REVISED STAFF REPORT: 06/12/2024 MEETING
APPLICATION NUMBER: HDC20204-00318
ADDRESS: 1475 LONGFELLOW
HISTORIC DISTRICT: BOSTON-EDISON
APPLICANT: TIM FLINTOFF (4545 ARCHITECTURE)
OWNER: SHARIF AFFAS
DATE OF PROVISIONALLY COMPLETE APPLICATION: 5/20/2024
DATE OF STAFF VISIT: 5/29/2024

SCOPE OF WORK: ERECT REAR ADDITION

Photo (below) of current rear wall/addition erected without HDC approval and off permit. Drawing (above) depicts proposed rear elevation. The applicant is seeking approval to retain the rear addition with some revisions to/addition of window openings

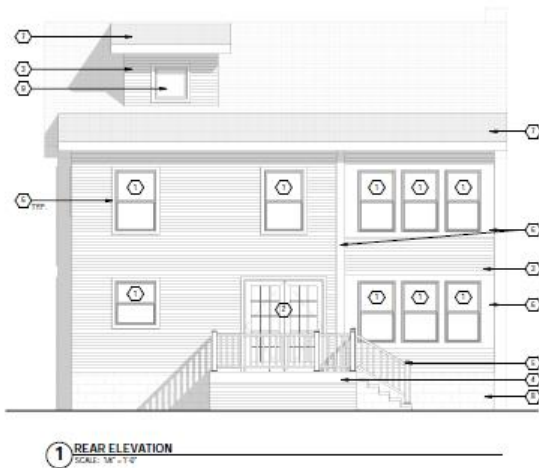
- It is staff's opinion that the newly erected rear addition does not meet the Standards for the following reasons:
 - Its construction has resulted in the removal of the significant historic-age one-story, sunroom bay which was formerly located at the building's southeast corner.
 - The addition has been appended directly to the rear elevation, with no relief/daylight between the new construction and original building as it is two-stories in height and extends the full width of rear elevation. As a result of its scale, the addition has completed altered the historic character of the building's rear elevation.

- Finally, staff recommends that the Commission deny the newly erected rear addition because it does not meet the Standards for the following reasons:
 - Its construction resulted in the removal of the significant historic-age one-story, sunroom bay which was formerly located at the building's southeast corner.

- The addition has been appended directly to the rear elevation, with no relief/daylight between the new construction and original building as it is two-stories in height and extends the full width of rear elevation. As a result of its scale, the addition has completed altered the historic character of the building's rear elevation.

1475 Longfellow, current appearance of front elevation primary entrance. Photo provided by applicant. Detail of new front door and sidelites. Note that the historic fluted pilasters which flank the front door still remain.

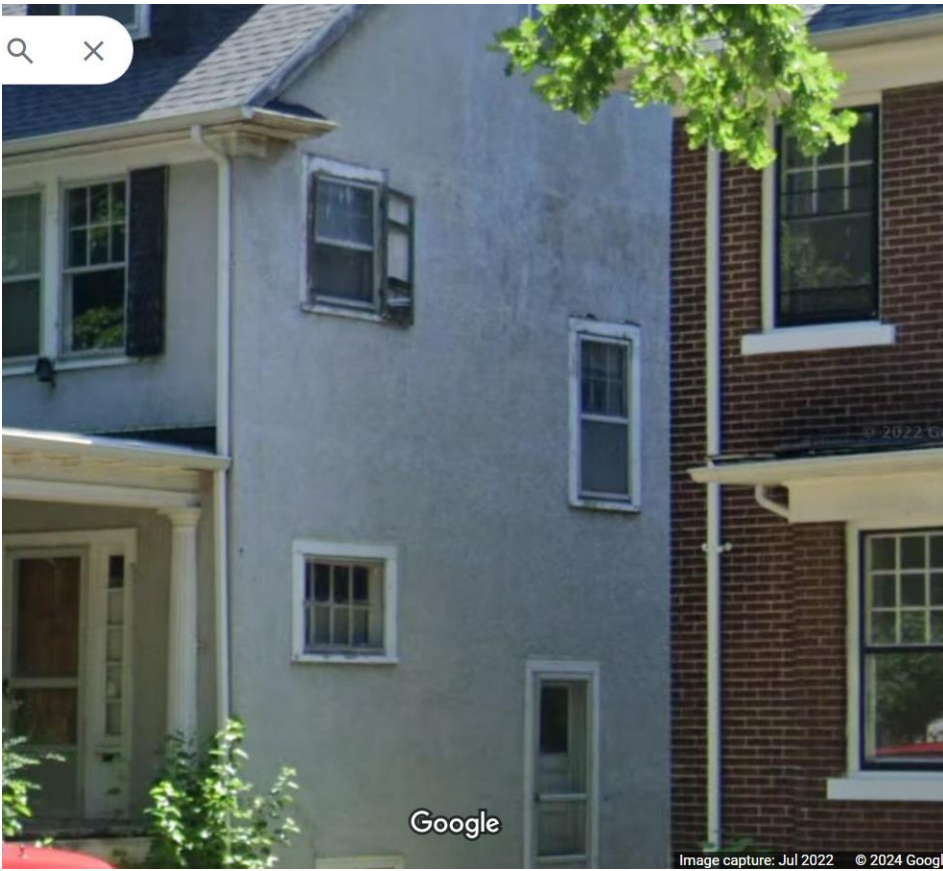
- New front door and sidelites. Note that the new elements will not replicate the distinctive front door trim which was extant as recently as December 2023. Also, the final material choice for the new door and sidelites have not been outlined. Staff therefore recommends the Commission deny this scope item

- New fiberglass columns and pilasters at front elevation porch. The original wood pilasters which flank the front door remain and do not appear to be deteriorated beyond repair. In re: to the two original wood columns which were replaced without approval, the application has not included information which indicates that they were deteriorated beyond repair. Also, it is possible to obtain new columns which match the old in material, detailing, and dimension. Staff therefore recommends that the Commission deny this scope item

- The current application does not provide documentation that the original door, trim, and sidelites that were replaced without HDC approval were deteriorated beyond repair. These were distinctive features that characterized the historic property. Also, the proposed new elements will not replicate the original distinctive front door trim which was removed without approval. Finally, the current application does not specify the new door and sidelite material.

- The original character-defining wood pilasters which flank the front door remain and do not appear to be deteriorated beyond repair. Also, the current application has not included information which indicates that two distinctive, character-defining wood columns at the front porch were deteriorated beyond repair. Finally, it is possible to obtain new columns which match the old in material

West elevation, staff photo taken on 5/29/2024. Note that shutters and the original wood door at the first story has been replaced with a metal door with a fanlight vision panel. Also, note four new windows have been added

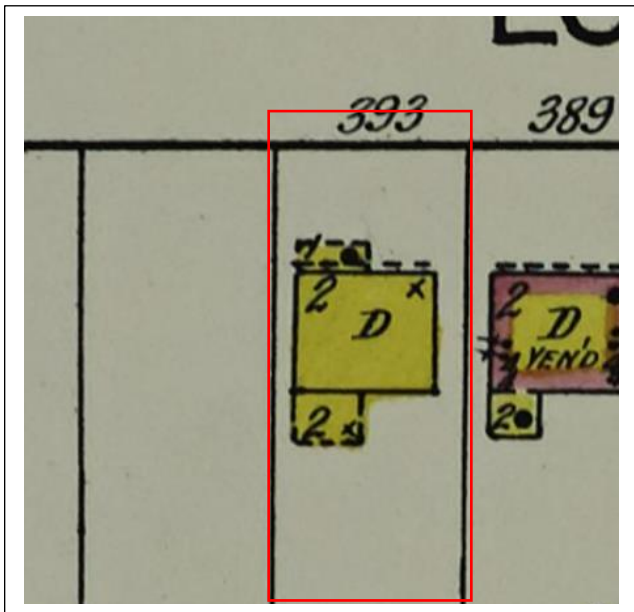
- New Fibrex windows at the side elevations and rear roof dormer. Note that none of the proposed new windows match the old in material, detail, operation, or lite configuration. Staff therefore recommends that the Commission deny this scope item.

- New west elevation door. Staff recommends that the Commission deny this scope item because the style and material of the proposed new door does not match the historic-age door that was replaced without HDC approval

- The current application does not provide documentation that the windows that were replaced without HDC approval were deteriorated beyond repair. These windows were distinctive features which characterized the historic property. Also, the new Fibrex windows at the side elevations and rear roof dormer do not match the old in material, detail, operation, or lite configuration.

- The current application does not provide documentation that the wood door at the west elevation which was replaced without HDC approval was deteriorated beyond repair. The wood door was a distinctive feature which characterized the historic property. Also, the proposed new door does not match the historic-age door in material or design
